Item Name: Crosstube Turning Detail

DART AEROSPACE LTD		Work Order:	92718
Description: Crosstube Assembly (205/212/412 High Fwd)		Part Number:	D212-664-141
Inspection Dwg: D212-664-141 Rev: D		Page 1 of 2

DRAWING NO. D212-664-141	TITLE XTUBE ASSY (205/212/412 HI FWD)	REV. D	DART AEROSPACE LTD ENGINEERING ORDER		D.E.O. NO. D212-664-141-D-1	SHEET NO. SHEET 1 OF 2	SCALE NTS
DRAWN	CHECKED	MFG. APPR.	APPROVED	DE APPR.			
DATE 11.04.07	DATE 11.04.11	DATE 11.04.12	DATE 11/04/12	DATE 11.04.12

DRAWING NO. D212-664-141	TITLE CROSSTUBE ASS'Y (205 HI FWD)	REV. D	DART AEROSPACE LTD ENGINEERING ORDER		D.E.O. NO. D212-664-141-D-2	SHEET NO. SHEET 1 OF 1	SCALE NTS
DRAWN <i>UP</i>	CHECKED <i>A>S</i>	MFG. APPR. <i>AS</i>	APPROVED <i>MD</i>		DE APPR. <i>HH</i>		
DATE 11.07.15	DATE 11.07.20	DATE 11.07.21	DATE 11/07/21		DATE 11.07.21

**D212-664-141/-141B
ASSEMBLY DETAIL**

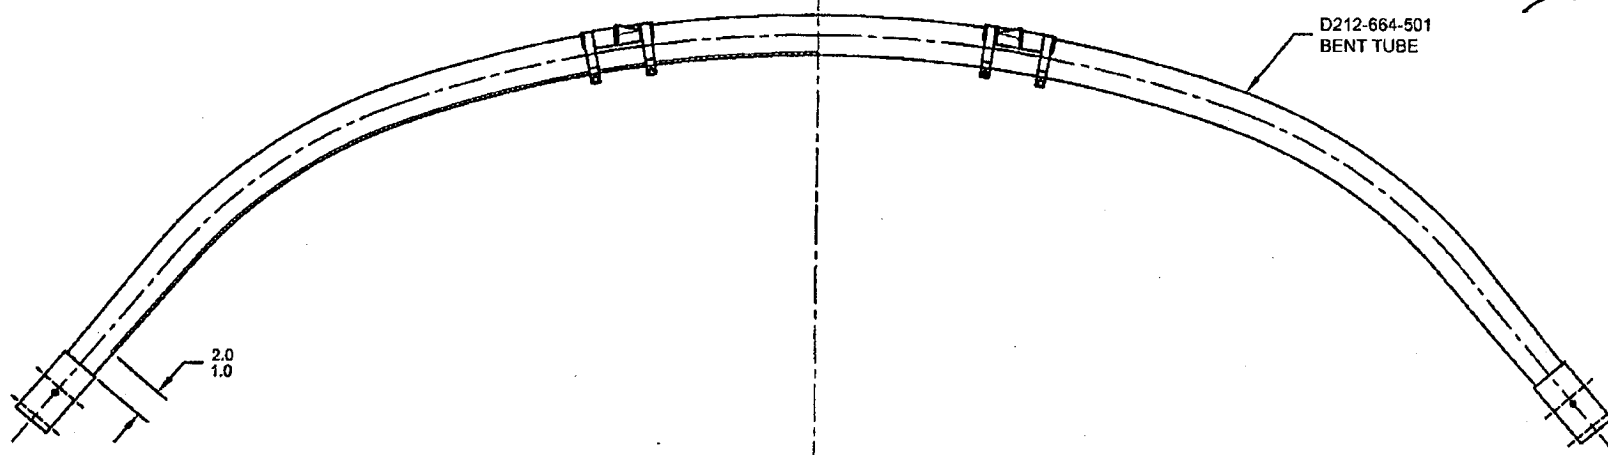
PURPOSE:

ADD AN INSPECTION WINDOW TO UNDERSIDE OF CROSSTUBE.

NOTES 2 OF SHEET 1 IS AMENDED AS FOLLOWS:

- 2) FINISH: CHEMICAL CONVERSION COAT PER DART QSI 005 4.1
PRIME INSIDE AND OUTSIDE PER DART QSI 005 4.2
MASK UNDERSIDE OF CROSSTUBE AS SHOWN (HATCHED AREA) AND
PAINT OUTSIDE PER DART QSI 005 4.2
REMOVE MASKING AND APPLY CLEAR COAT

- 2) FINISH: CHEMICAL CONVERSION COAT PER DART QSI 005 4.1
PRIME INSIDE AND OUTSIDE PER DART QSI 005 4.2
PAINT OUTSIDE PER DART QSI 005 4.2

MASK AREA PRIOR TO PAINTING,
REMOVE MASKING AFTER PAINT
AND APPLY CLEAR COAT
